ON-SITE SEWAGE DISPOSAL SYSTEM
HOWARD COUNTY HEALTH DEPARTMENT
BUREAU OF ENVIRONMENTAL HEALTH

05-361427

SUBDIVISION: Riverside Estates LOT NUMBER: 11

ADDRESS: 10702 Judy Lane PROPERTY OWNER: Bruce Michael Levey

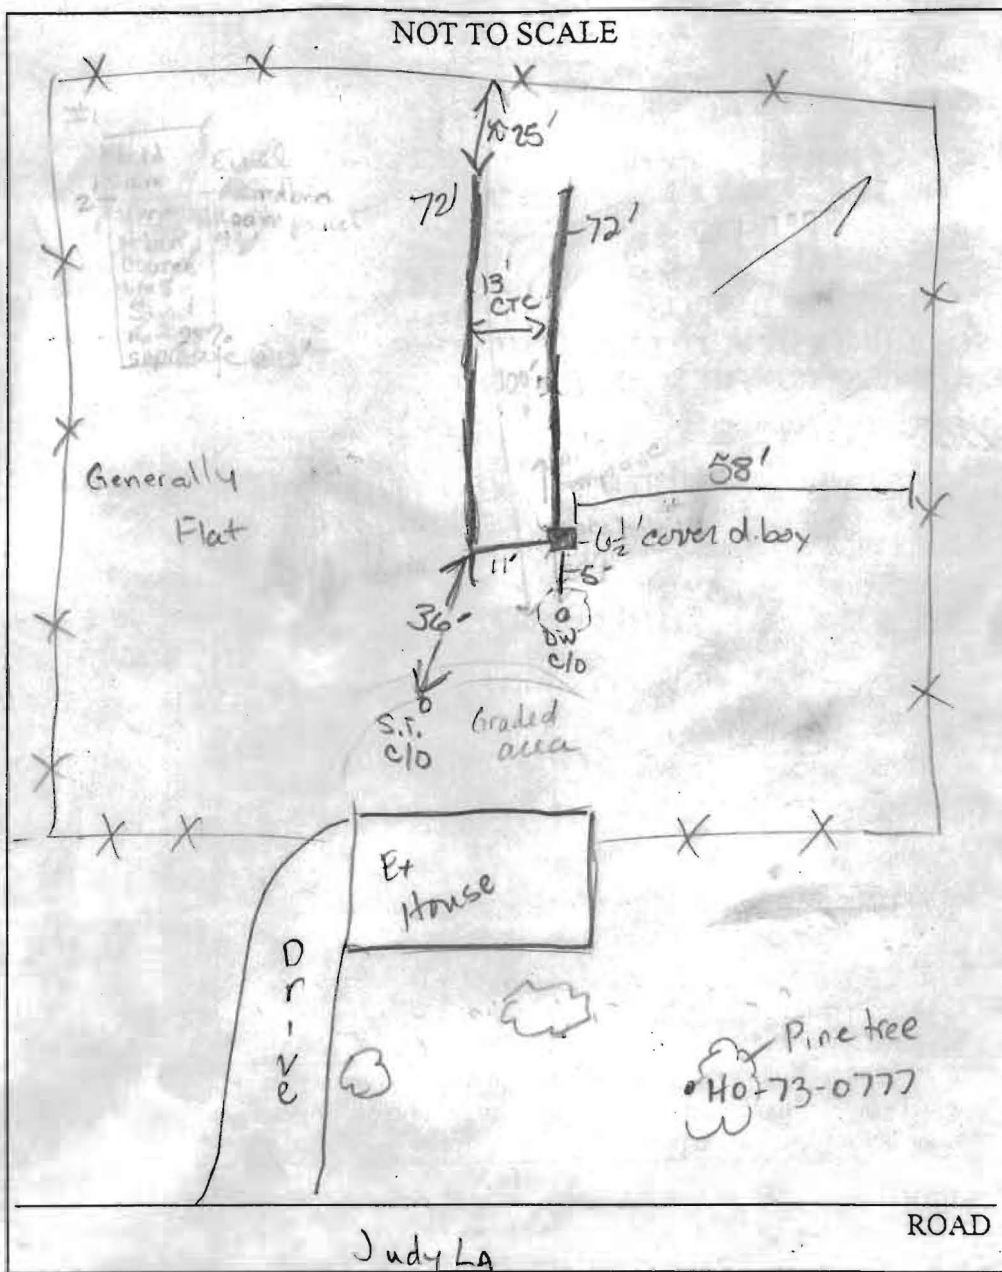
TRENCHES:	Trench to be <u>2</u> feet wide. Inlet <u>7</u> feet below original grade. Bottom maximum depth <u>9</u> feet below original grade. Effective area begins at <u>5 1/2</u> feet below original grade. <u>2 1/2</u> feet of stone below distribution pipe.
LOCATION:	<u>Run 100' long trench from dry well and on contours or 2-75' trenches w/d. box</u>
PURPOSE:	Septic system has failed. Call for inspection when the ground is opened so sanitarian can recommend repair.

PRE-CONSTRUCTION ^{6/24/03} Surrounding wells in front yards. Lots 10 + 12 (neighbors) have s.i.m soil profiles with 10% rc. Ex. system on INSTALLATION this prop. not per previous installation requirements. Instead, a deep system was installed. Plumbing from house under footer. Run a 100' long trench from existing drywell on contour. SEE PERC NOTES FOR MORE DETAILS (KN)

6/27/03 Final inspection. Left message on machine for Zepp Plumbing indicating 7' inlet, bottom @ 9'. Zepp Plumbing placed bottom at 11 1/2' - still OK.

Cover trenches.
